**From:** Williams, Jeffrey  
**Sent:** Friday, February 27, 2015 1:34 PM  
**To:** 'Michael Boyce'  
**Cc:** 'Nathan Brandenburg'; 'Ryan Ketner'; 'Kevin Davis (kevin@foglesinc.com)'; Wolf, Kevin; Baker, Brian  
**Subject:** RE: Edgewood lot 37

PLOT PLAN  
 LOT 37  
**EDGEWOOD FARM**  
 LIBER 10677, FOLIO 461  
 PLAT NO. 19269  
 FOURTH ELECTION DISTRICT  
 HOWARD COUNTY, MARYLAND

PERCOLATION CERTIFICATION REVISION  
LOT 37  
**EDGEWOOD FARM**  
LIBER 10677, FOLIO 461  
PLAT No. 19269  
TAX No. 04-372654  
FOURTH ELECTION DISTRICT  
HOWARD COUNTY, MARYLAND  
ADDRESS: 14553 EDGEWOODS WAY  
GLENELG, MARYLAND

Test Hole  
Locations

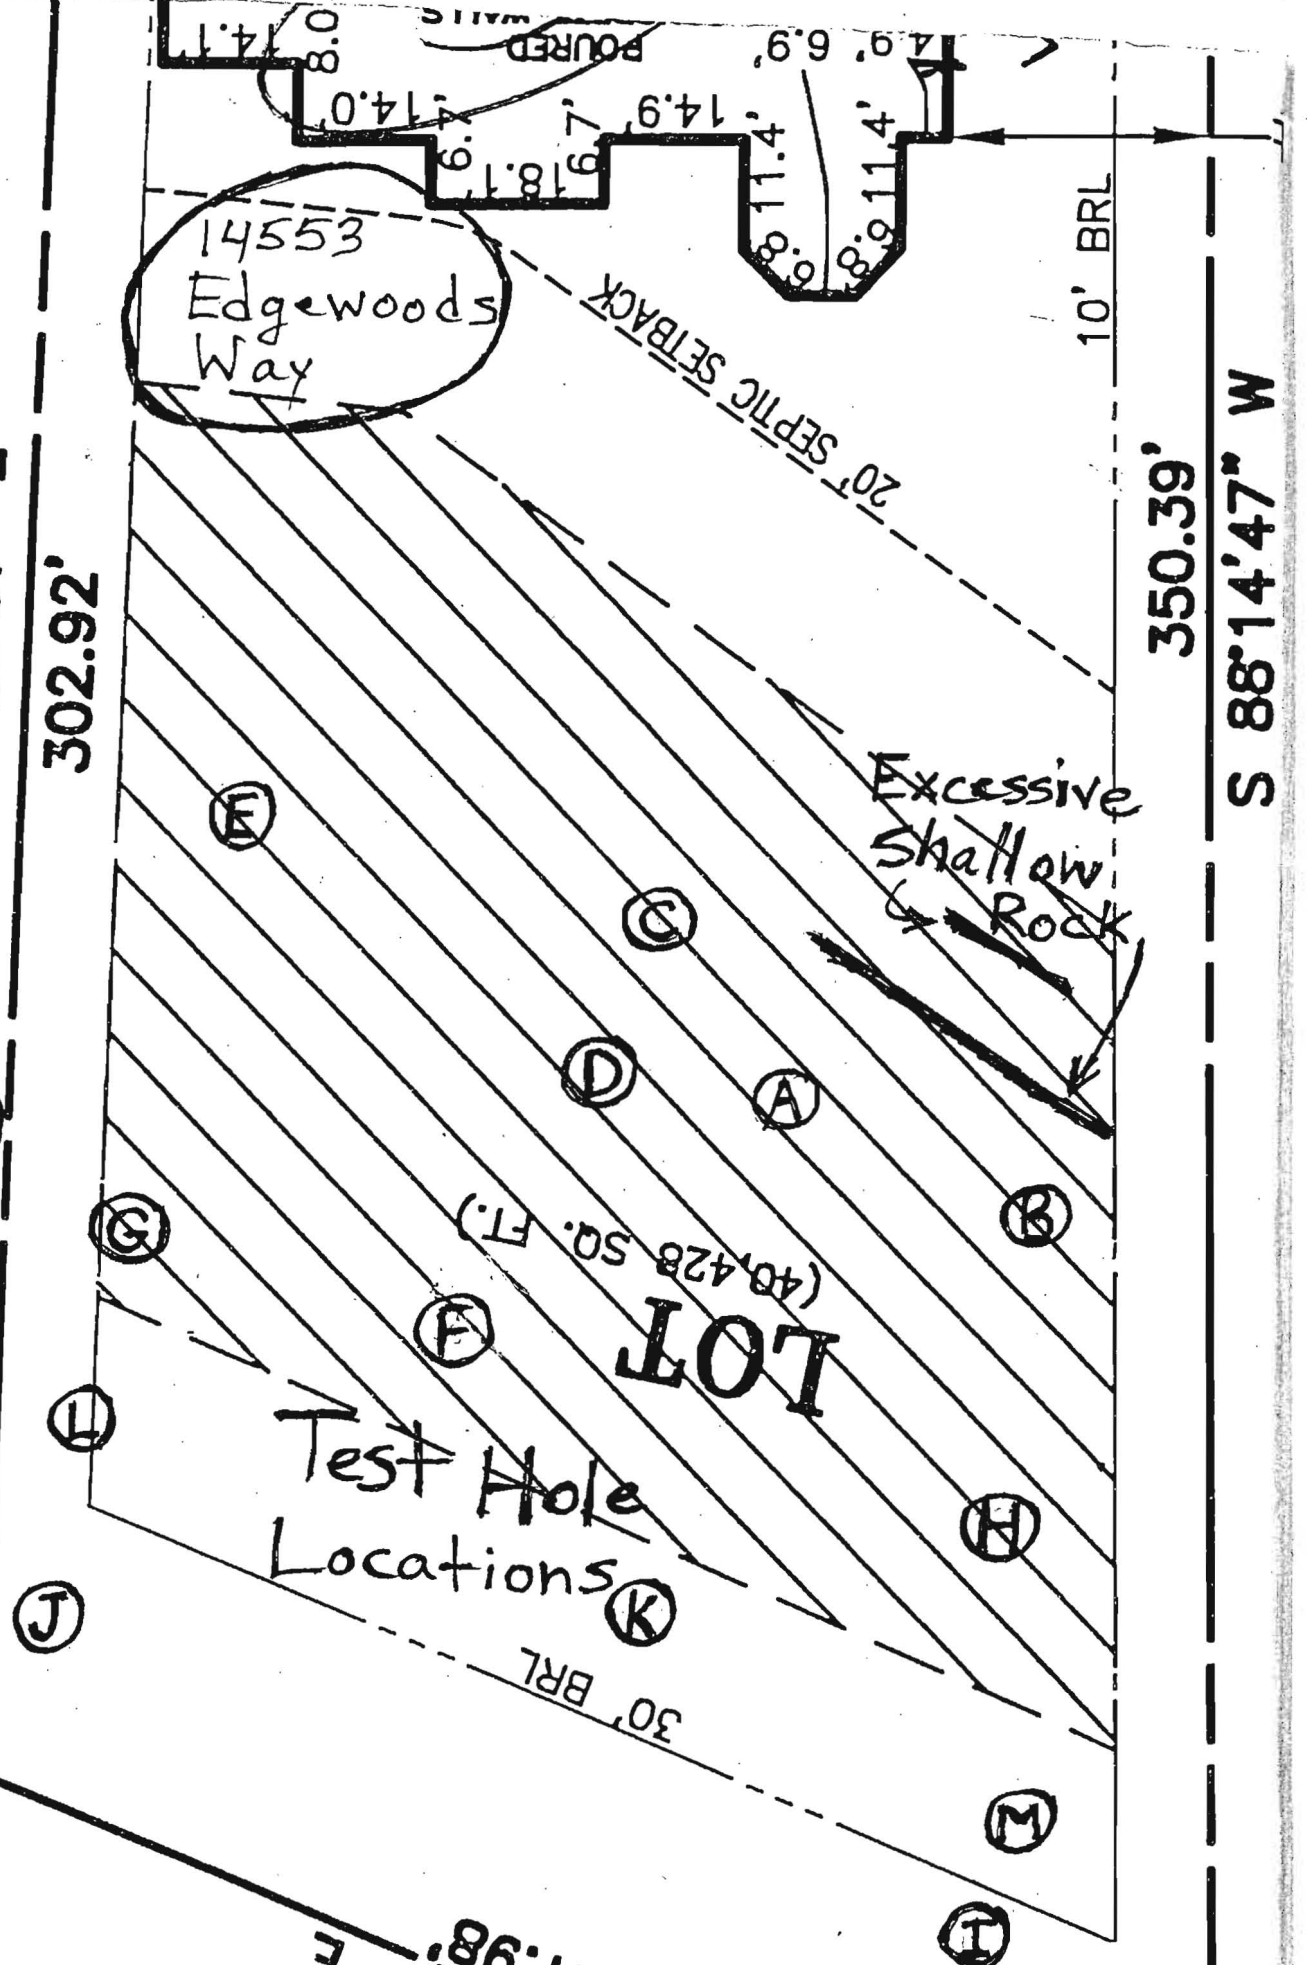
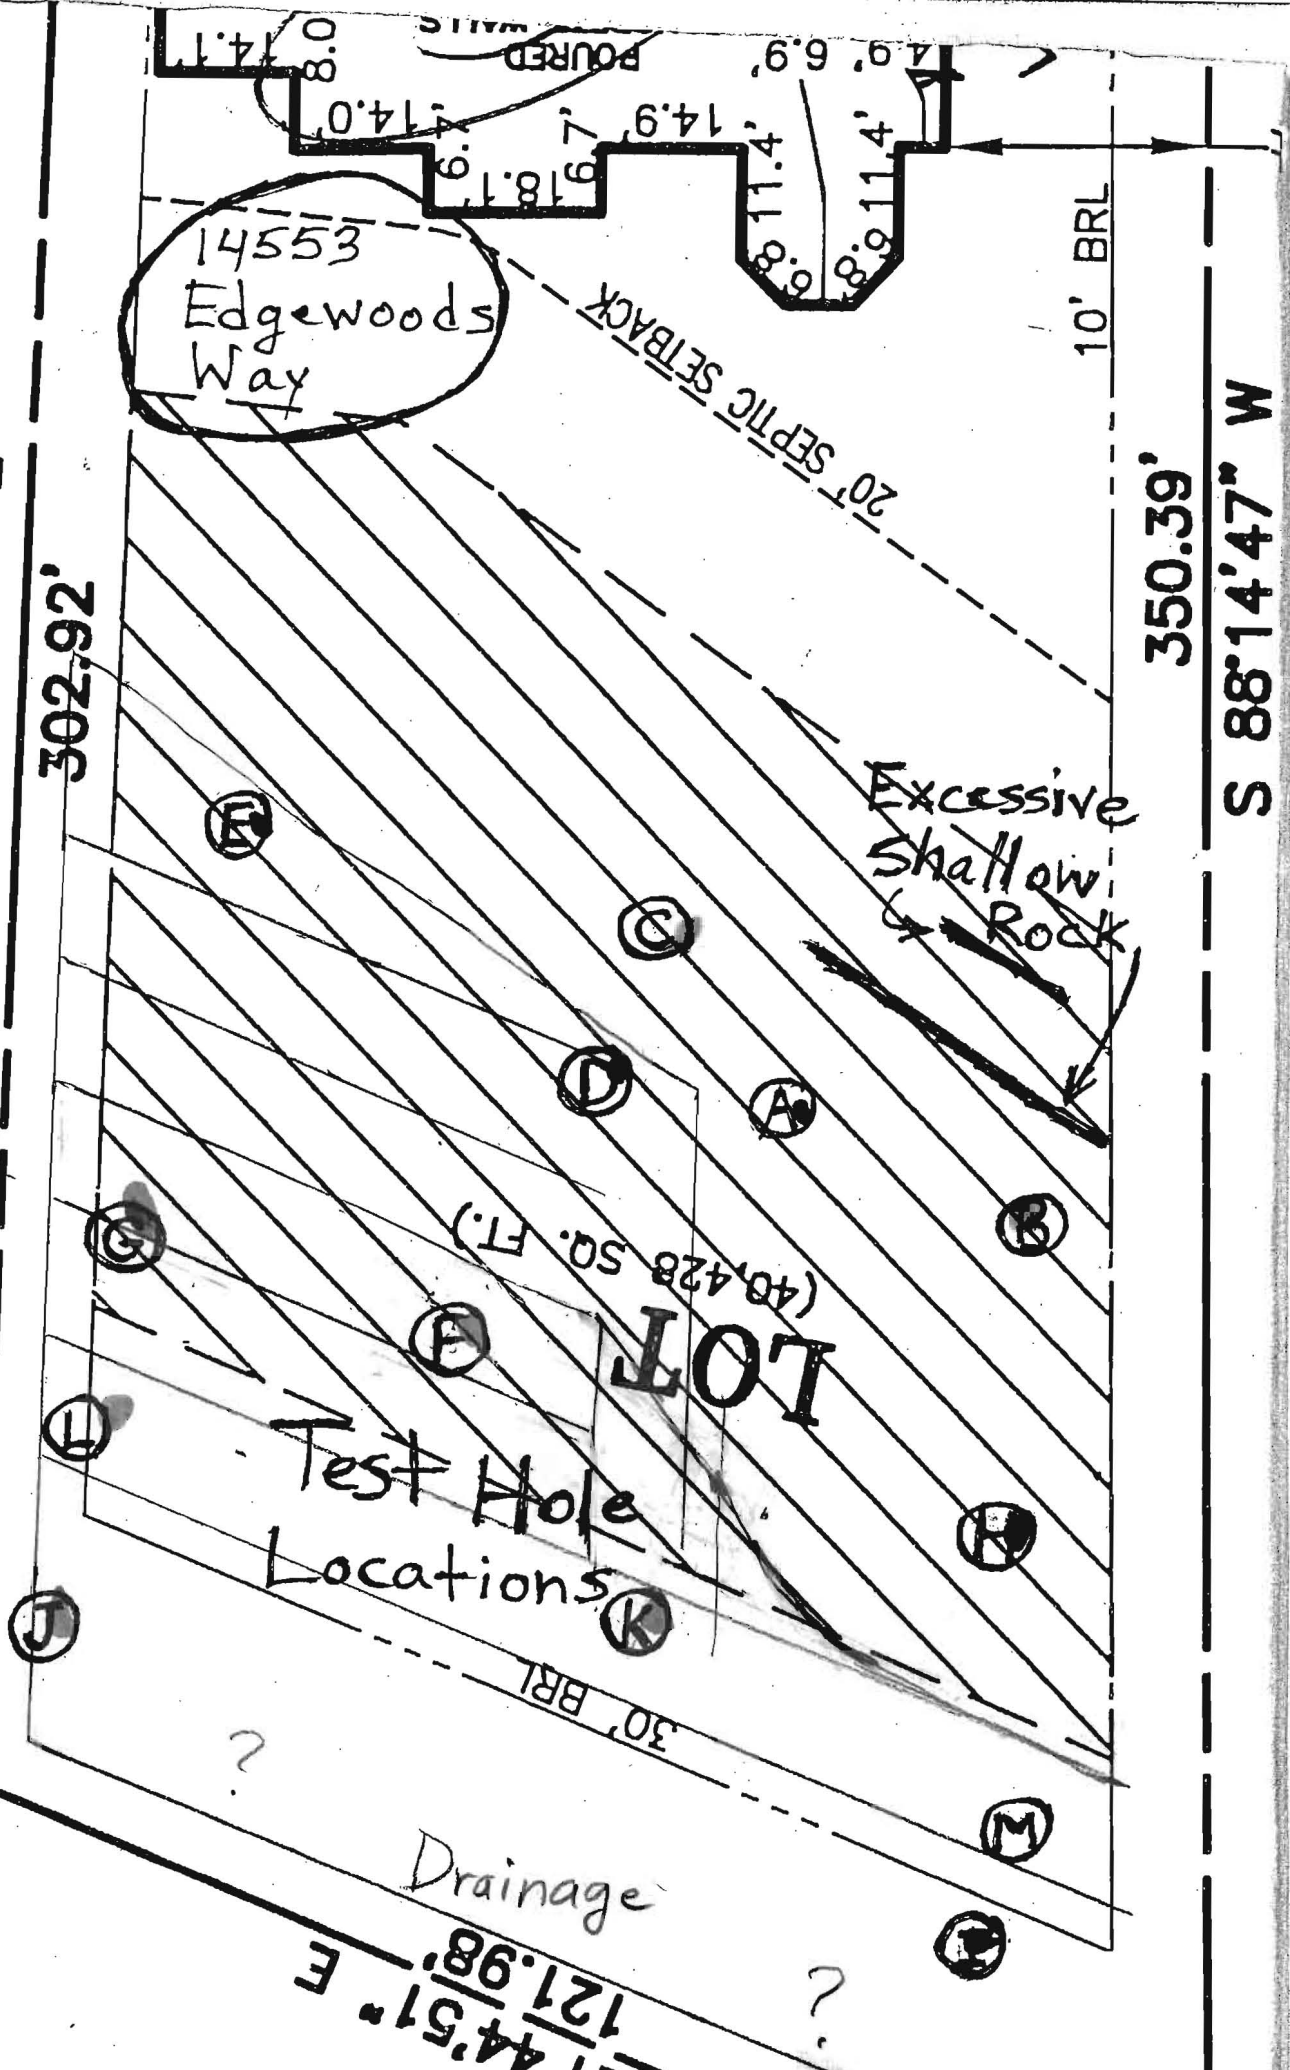
Excessive  
Shallow  
Rock

Mike, please see the attached documents. Brian has identified an overall area that appears to be able to support conventional septic and miss the shallow rock based on the test holes he dug. He also drafted a possible location for the initial system, which could be a low pressure dosed bed in the bottom corner. That would leave the upper part of the revised area near holes D&E for a future repair. He gave some specs for bed depth and lateral placement.

## Bed Side View -

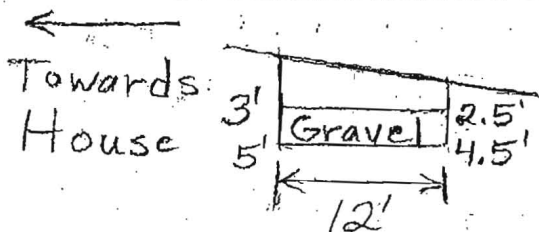
# 12' x 66' Bed -

- Inlet ~ 2.5'-3'
- Bottom ~ 4.5'-5' } 2' Gravel + Enough to Cover Laterals
- Myers ME50 120V 1/2 H.P. Pump or Equivalent
- Pretreatment: HOOT H-600 BNR Which Has a 750 Gallon Pump Chamber
- Clean Gravel
- 3" Force Main, 1/2" Laterals

- Lay Out the Bed on Contour
- Find the Lowest Area of the Bed and Make This 4.5' Deep, This Is the Reference Point
- Keep the Rest of the Bed Bottom Level
- Keep Everything Else Level (Gravel, Laterals, etc)

2/27/2015  
Revised Easement  
Location

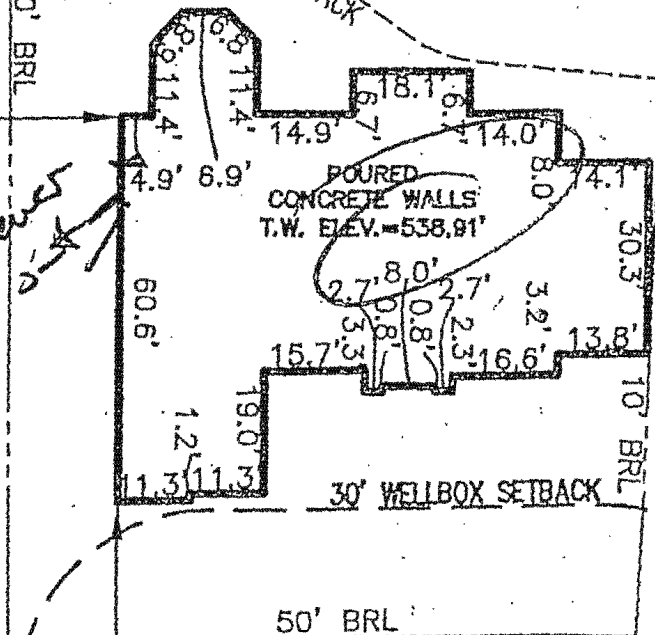
What we'll need to proceed is a revised design from you with the details of the LPD including dose, head, and pump info. Brian included specs for a possible pump choice. What we provided in terms of the system design is a recommendation. We will also need a revised perc cert showing the revised area based on the attached plan and showing the new test hole locations. We do not need to sign the perc cert before starting installation. If you give us the perc cert and the design plan together, we can start installation while we get the cert signed.
